AGENDA ITEM: # 2

CASE NUMBER: P.D. 18-18 (CORRES.)

**DEVELOPMENT:** Delta Square P.D.

**REQUEST:** 1). Add Parcel 07400100243 to the boundary of the P.D. pursuant to the conditions

# Site plan for Major Modification Application

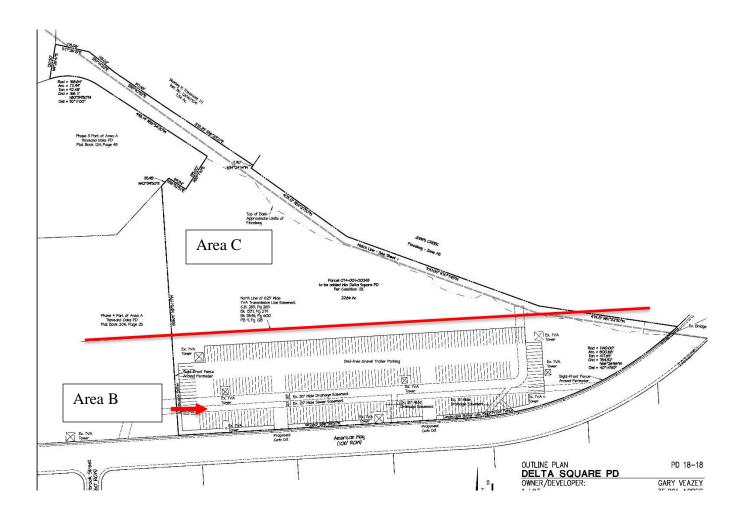
**New Area A** – The portion of this request that removing the required building materials from the façade of the Shop Building is a reasonable request. The site plan shows the Shop Building relocated behind an existing building that is outside of the P.D. and sits between the Shop Building and the American Way right of way. Thus, it will be out of the direct line of sight for passers-by along American Way.

The first is a change in the location of the mechanic's shop building in the area of the P.D. being labeled Area A. If the new location is out of the direct line of site of the right of way of American Way, staff has no opposition to modifying the conditions regarding the treatment of the building façade.

- C. The proposed Shop Building shall be composed of masonry materials, no exposed metal will be permitted. The colors of buildings on site shall match. If the Shop Building is moved to a location on site that is not directly visible from the American Way right of way, this condition will not apply and a metal façade is permitted.

Subject Property Areas B & C

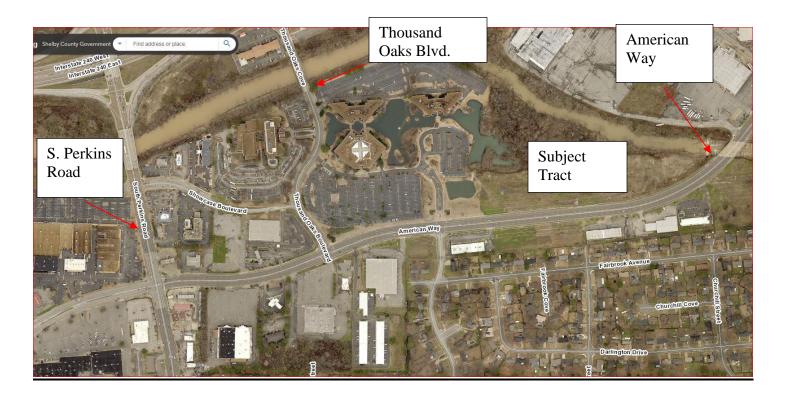
In the view of staff, this challenge must be successfully met or the Final Plat will not be forwarded to City Engineering as a part of the plan review process. Conditions have been promulgated to effectuate such an outcome.

Area A is the original application that is the former Delta Square Shopping Center. Area B is the active area of the new parcel that lies between the right of way of American Way and the north line of the TVA transmission easement which is identified on the submitted Concept Plan. Area C is the remaining area which is located between the north line of the Transmission Easement and the boundaries of John's Creek.
